To: Linda Hanson
Staff Environmental Scientist
Department of Fish and Game
Central Coast Region
P.O. Box 47
Yountville, CA 94599

June 28, 2006

From: Kit H. Custis PG3942, CEG1219, CHG254
Senior Engineering Geologist
Department of Conservation
Office of Mine Reclamation
801 K Street, MS 09-06
Sacramento, CA 95814-3530

Subject: Comments on June 2006 Notice of Preparation and Initial Study for El Sur Ranch Water Rights Application No. 30166, Monterey County, California

Figure 1

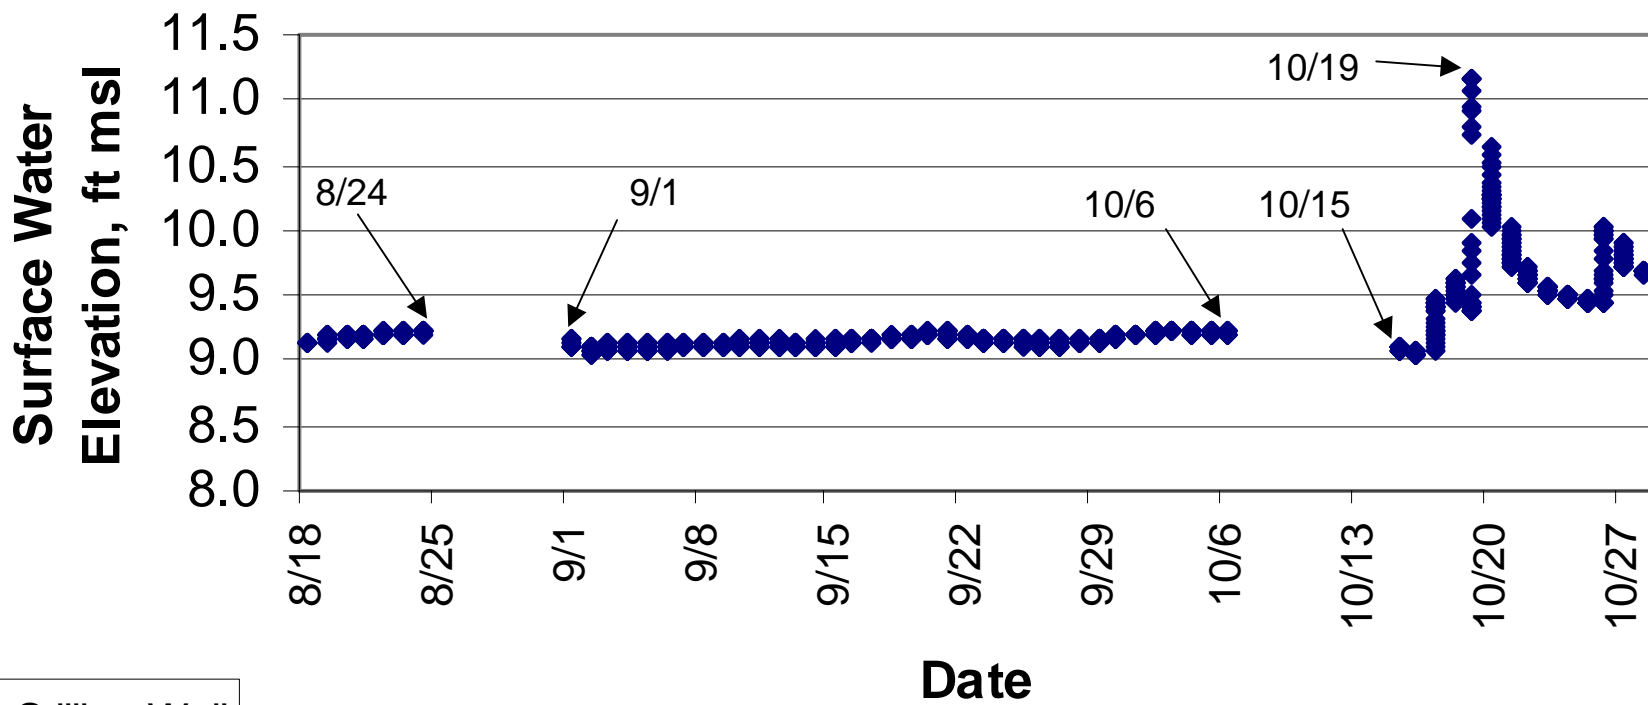
in surface water and groundwater levels as the result of increasing the pumping from one to two wells as discussed in SGI section 3.4.8.1 and as shown in SGI Figure 3-35. SGI Figure 3-35 shows the water levels dropping from mid-September to early October in 2004 at the stilling well in the river adjacent to VT #2 and in monitoring well ESR 10-B. The SGI report noted that the surface water level dropped approximately ½ inch and the ground water in the well dropped approximately 1 foot as a result of increased pumping. While this may not appear to be much of a physical change to the river, it is a significant change in hydraulic gradient between the river and well. The change in hydraulic gradient is a measure of the significance of increase, or decrease, in pumping because ground water flow is governed by Darcy’s Law ($Q = k \cdot i \cdot A$). Assuming the hydraulic conductivity (k) and cross-sectional area (A) are not significantly changed, then the change in hydraulic gradient (i) quantifies the change and level of impact. As the Initial Study noted, ground water losses or gains to a river do not generally occur at a single point, but are spread along the river reach. Thus, the total change in flow can’t be measured at a single point but must be measured between at least two points placed on either side of the impacted reach. By the statement of “no noticeable impact,” the Initial Study appears to expect that the impacts from pumping the wells will be similar to a diversion into a pipe or canal, all occurring at one point on the river. The following discusses the significance of the hydraulic changes measured when the pumping rates varied.

- c. A second opportunity to evaluate the impacts of pumping on river flow was made by using data from mid-October 2004 when both wells were turned off (see SGI Figure 3-36). Following cessation of pumping on October 16, 2004, there was no immediate rise in surface water elevation at the stilling well near VT#2. In fact, an analysis of the daily average elevation at the stilling well indicates that it dropped approximately ½ inch from October 15th to October 16th (see the ESR technical reports data). The surface water elevation began to rise the following day likely in response to the rain event on October 17th and 18th. If pumping ceased, why did the surface water level drop?

Figure 2

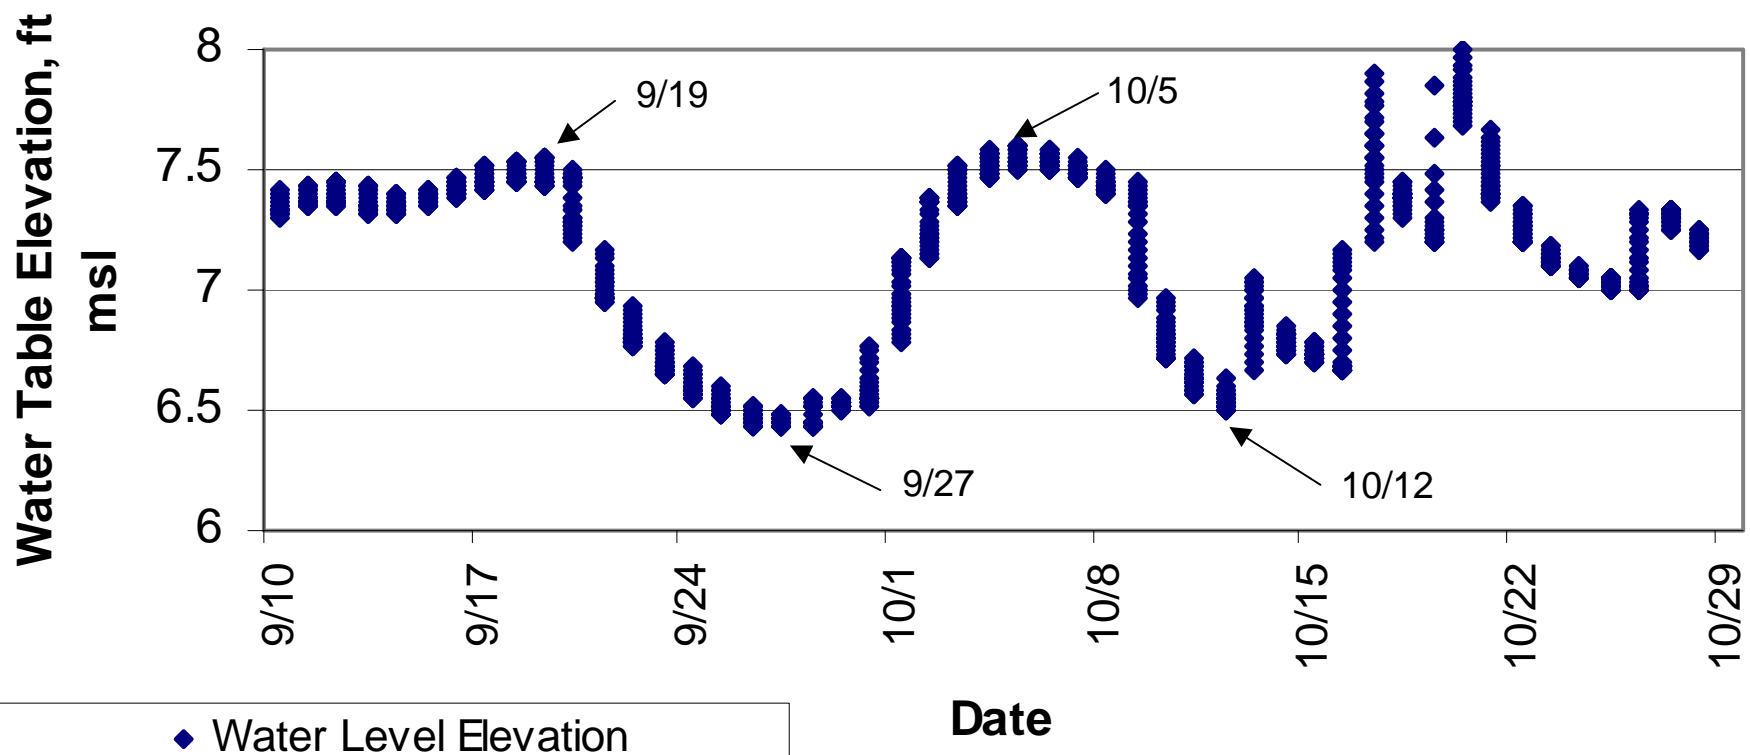
in hydraulic gradient. With an almost doubling of the pumping rate, the hydraulic gradient between VT#2 and ESR 10-B increased approximately 50 percent (SGI Figure 3-36). This increase in gradient agrees with the analysis by Miller and Durnford (2005) that when the rate of stream depletion approaches the rate of pumping, then approximately half of the seepage occurs within a reach of stream centered on the well, the length of which is twice the closest stream-to-well distance. For the study area, the river's closest point to the New Well is approximately 500 feet away (see SGI Figure 2-2) and VT#2 is approximately the same distance upstream. Therefore, with the 88% increase in pumping rate, the hydraulic gradient of ground water increased by approximately 50%, which suggests an increase in seepage losses from the river of approximately 50%.

Figure 5

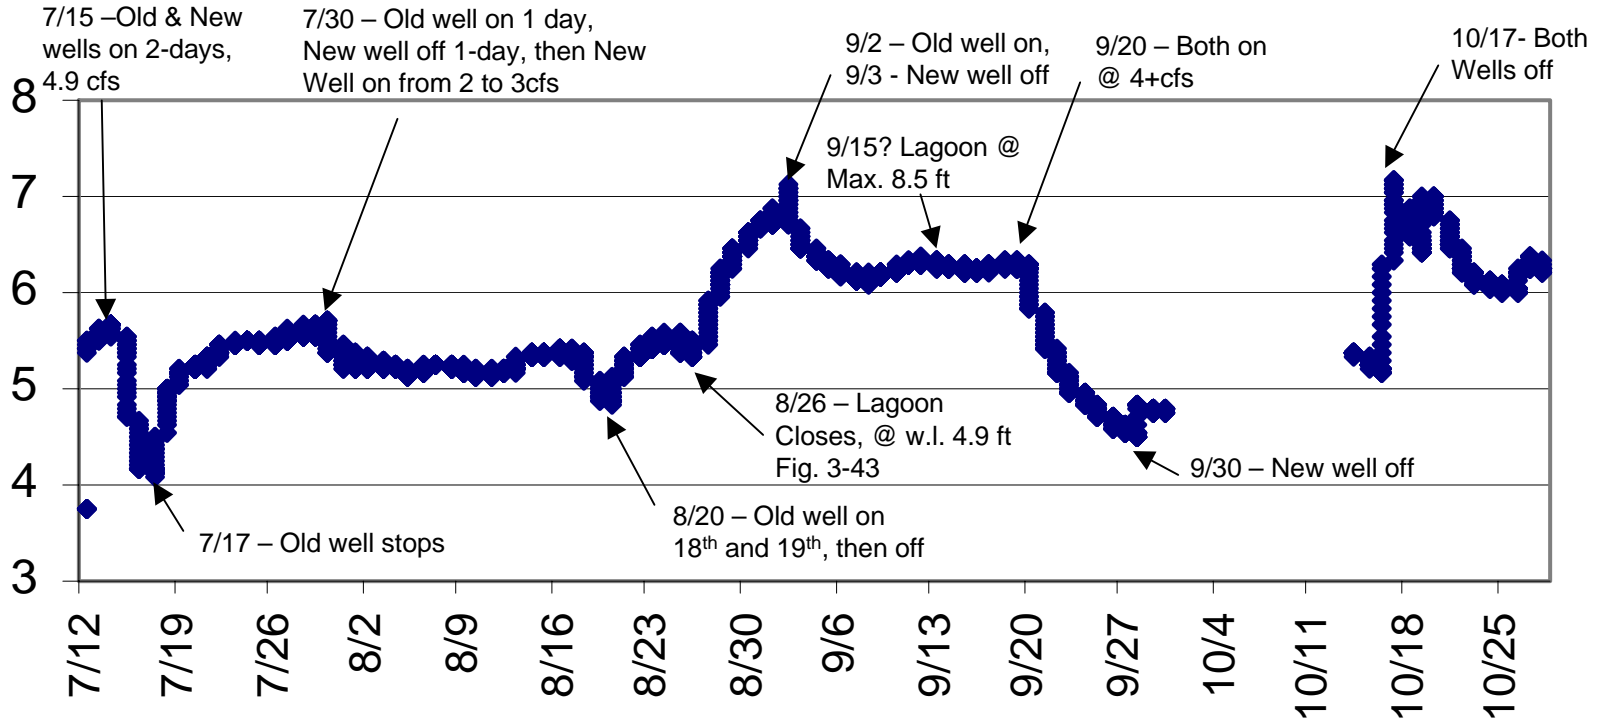
- d. On August 26, 2004, when a sand bar closes the river’s outlet, the lagoon surface water level starts rising from approximately 5.2 feet above msl and reaches 8.5 feet above msl by mid-September (see SGI Figure 3-43 and section 3.4.8.3). By the end of September, the lagoon surface drops to approximately 6.75 feet above msl. Groundwater levels in monitoring wells also go up approximately 1.5 feet to 2.0 feet by the start of September (see SGI Figure 3-44 and section 3.4.8.3). By mid-September, groundwater levels drop back to below approximately 6.25 feet above msl. The attached Figure 5 shows the changes in groundwater levels at monitoring well ESR-02 which is representative of the effects of the

lagoon closure over a longer period than shown in SGI Figure 3-44. The rise in river stage with the closure of the lagoon may have extended upstream into the reach of the “cold pool” (see SGI Figures 3-28 and 3-29 for a comparison of lagoon water levels). The evidence for this can be found in the sampling depths of the water quality stations.

Figure 6

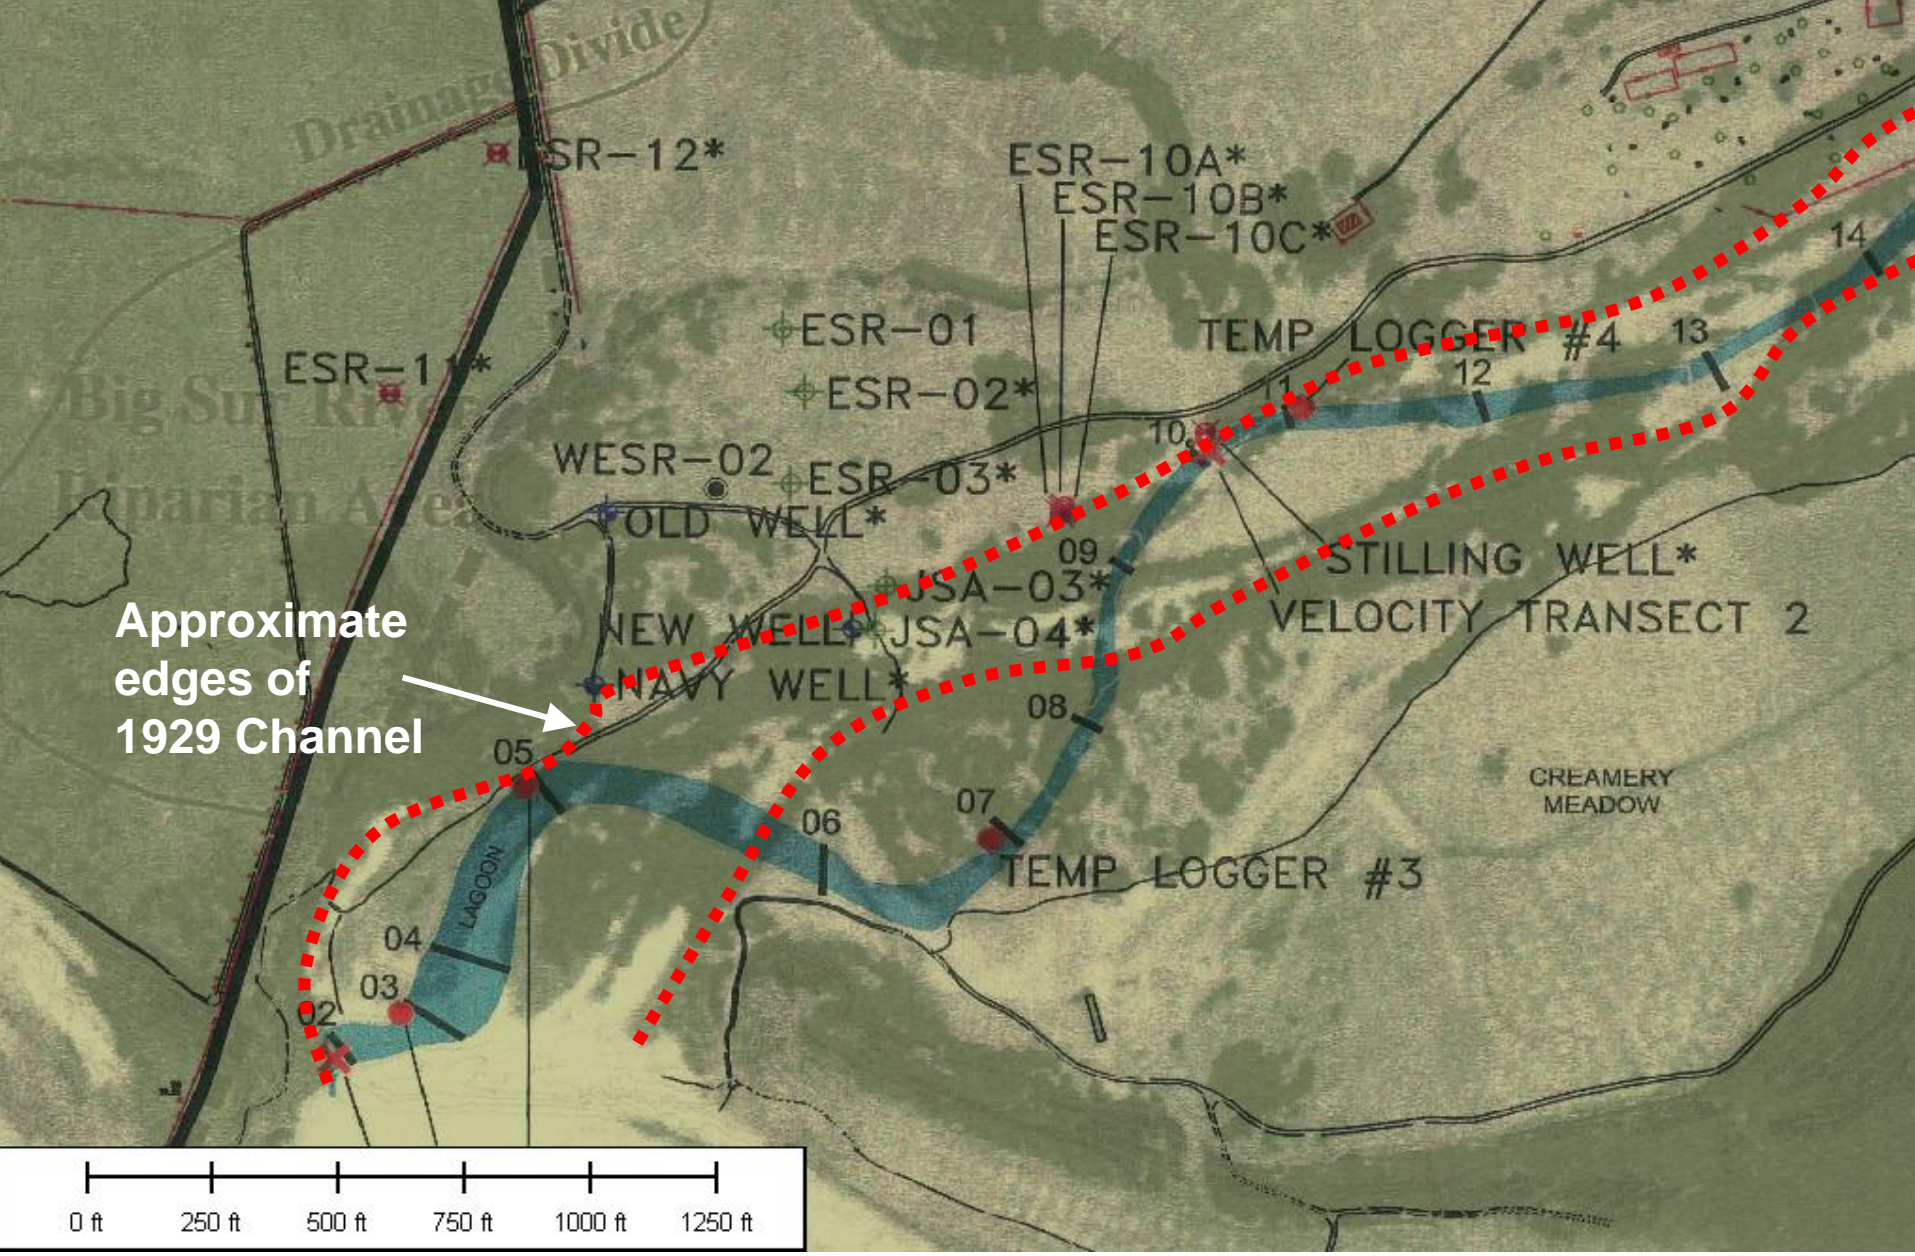
- h. **Review of historic aerial photos and topographic maps.** Figure 9-1 of the May 18, 2005 NRCE water use report shows the study area in 1929. A comparison of the 1929 river configuration to that of today (see attached Figure 6) clearly shows that today's sinuous channel next to the pumping wells was instead rather linear and a somewhat braided reach. This change in channel morphology may be an important feature in determining where to monitor, and may help explain the movement of ground water because the main channel of a river is often coarser grained than bank deposits and becomes a preferred flow path. Historic photos, aerial or ground based, would be a valuable source to document historic changes in channel morphology. Knowledge of any changes in the channel is critical in interpreting the existing data and in selecting monitoring points for the water rights permit. An effort should be made to collect and analyze these.
